Errata to the MPC7450 RISC Microprocessor Family Reference Manual, Rev. 5

This errata describes corrections to the *MPC7450 RISC Microprocessor Family Reference Manual*, Rev. 5. The MPC7450 is a PowerPC® microprocessor built on Power Architecture® technology. For convenience, the section number and page number of the errata item in the reference manual are provided in the left margin. Items in bold are new since the last revision of this document.

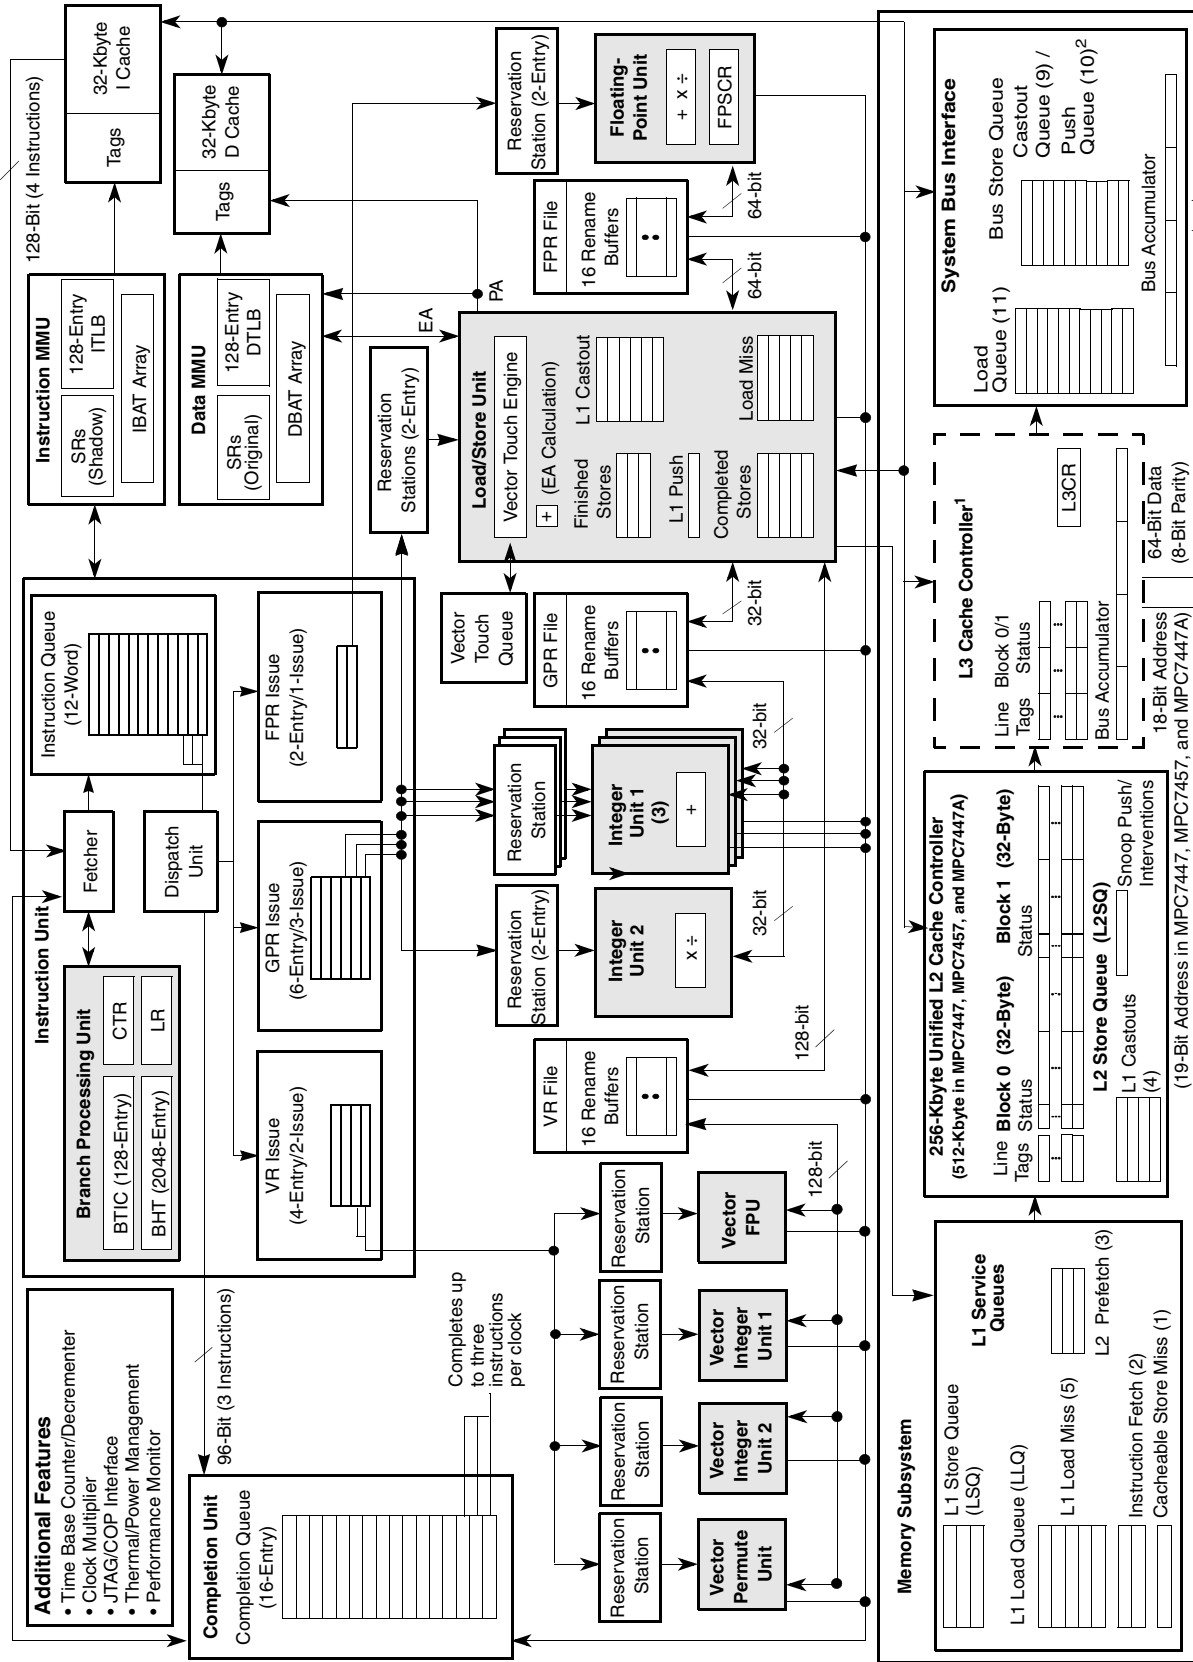
Section, Page	Changes
1.1, 1-4	The LSU, IU2, and FPU each have 2-entry reservation stations; all other execution units have 1-entry reservation stations. Clarify Figure 1-1, “MPC7450 Microprocessor Block Diagram,” to show this consistently, as follows:

Notes:

- The L3 cache interface is not implemented on the MPC7441, MPC7445, MPC7447, or MPC7447A.
- The Castout Queue and Push Queue share resources such for a combined total of 10 entries. The Castout Queue itself is limited to 9 entries, ensuring 1 entry will be available for a push. The MPC7447A has 5/6 entries.
